Docket Number:	08-AFC-08A			
Project Title:	Hydrogen Energy Center Application for Certification Amendment			
TN #:	201872			
Document Title:	AIR Status Report March 2014			
Description:	update on Savage facility expansion			
Filer:	Tom Frantz			
Organization:	Association of Irritated Residents			
Submitter Role:	Intervenor			
Submission Date:	3/13/2014 9:11:25 AM			
Docketed Date:	3/13/2014

RE: HECA docket # 08-AFC-8A

AIR Status Report for March 2014

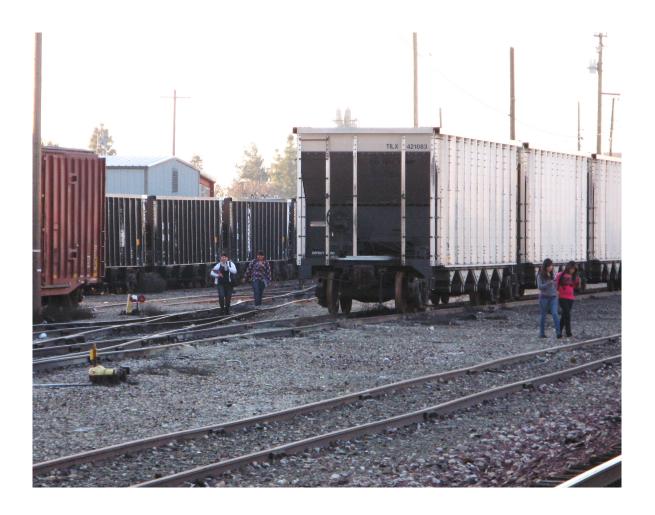
The photo below is of school children passing around the coal cars in the area immediately south of the Amtrak Station in Wasco. The photo was taken in February of 2011. This is a very dangerous situation. Even with fences repaired and signs to keep people from trespassing, this practice of taking a short cut across the tracks continues to happen on a daily basis by young and old alike.

The huge expansion of Savage operations will make this situation even more dangerous. I don't think you have adequately addressed this situation with this amendment.

Please consider asking Savage (HECA) to put in more secure fencing along the east side of these rail sidings. Also, ask Savage to improve the rail crossing on 6th Street and on Poso. Both of these crossings need sidewalks and lights for pedestrians. Alternatively, it would be appropriate to ask Savage for significant help in building a pedestrian overpass in the area of the Amtrak Station.
